STAFF REPORT
COMMUNITY DEVELOPMENT DEPARTMENT

HEARING DATE: 9/6/2022
 TO: Mayor & City Council
 FROM: Alan Tiefenbach, Associate Planner
 208-884-5533
 SUBJECT: H-2022-0038 and SHP-2022-0008
 Torino Locust Grove Subdivision
 LOCATION: 870 S. Locust Grove Rd.

Annexation of 1.03 acres of land with the R-8 zoning district, and short plat consisting of 4 residential building lots.

A. Annexation and Zoning Legal Description and Exhibit

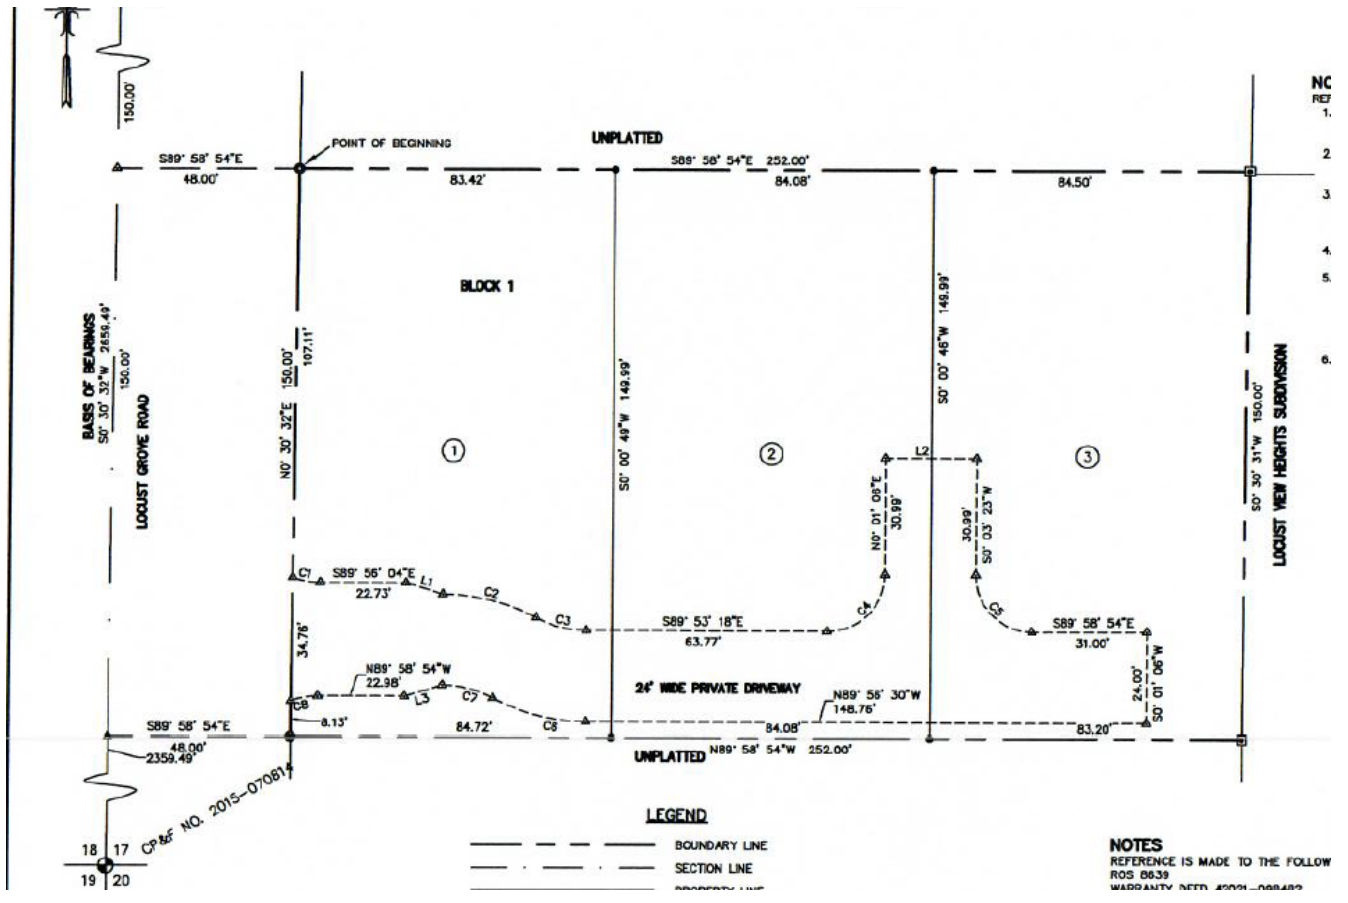
The submitted legal description and boundary exhibit to appear to encompass the area of annexation. However, the exhibit also includes a previous lot configuration of three lots. **Prior to recordation of the annexation ordinance, the applicant shall submit a revised boundary exhibit which correctly matches the legal description.**

3. Prior to recordation of the annexation ordinance, the applicant shall submit a revised annexation boundary exhibit.
 4. The applicant shall construct all proposed fencing and/or any fencing required by the UDC, consistent with the standards as set forth in UDC 11-3A-7 and 11-3A-6B, as applicable.

B. Short Plat (date: 5/20/2022)

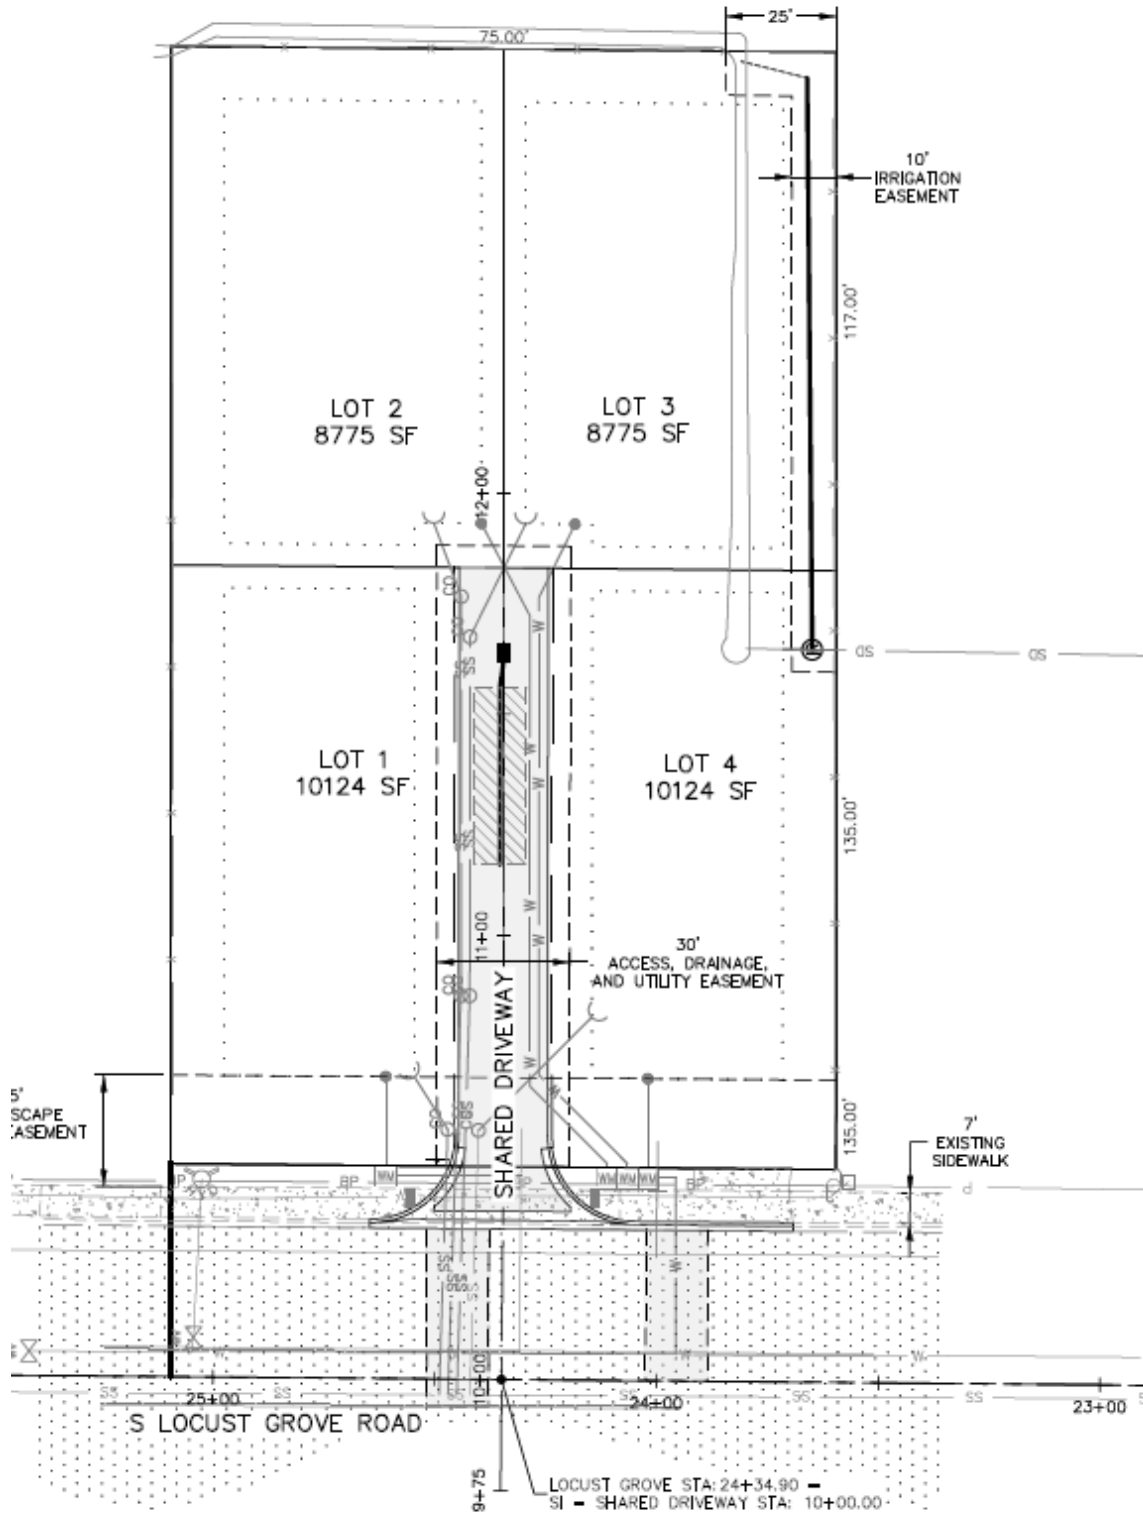
The applicant will be required to install a 25' wide buffer along S. Locust Grove Rd. as is required for arterial streets. Per UDC 11-3B-7, all street landscape buffers shall be on a common lot or on a permanent dedicated buffer easement, maintained by the property owner, homeowner's association or business owners' association. This is not reflected as such on the plat. Staff has added this as a condition of approval prior to City Engineer signature.

The landscape plan does not indicate whether there are any existing trees on the property that meet the preservation requirements of UDC 11-3B-10. This should be reflected on the landscape plan prior to City Engineer signature.

- b. The 20-foot common driveway shown in the short plat shall be extended to the eastern property line in a 30 ft wide easement common lot and receive Fire Marshall approval to exceed 150 feet in accord with UDC 11-6C-3D. When the property to the east annexes into the City and develops, access to the subject property shall occur from S. Torino Ave. and the existing S. Locust Grove Road access shall be closed or used for emergency access purposes only.

2. Prior to City Engineer signature, the short plat shall be revised to indicate the street landscape buffers on a common lot or on a permanent dedicated buffer easement, maintained by a property owner, or homeowner's association per UDC 11-3B-7.
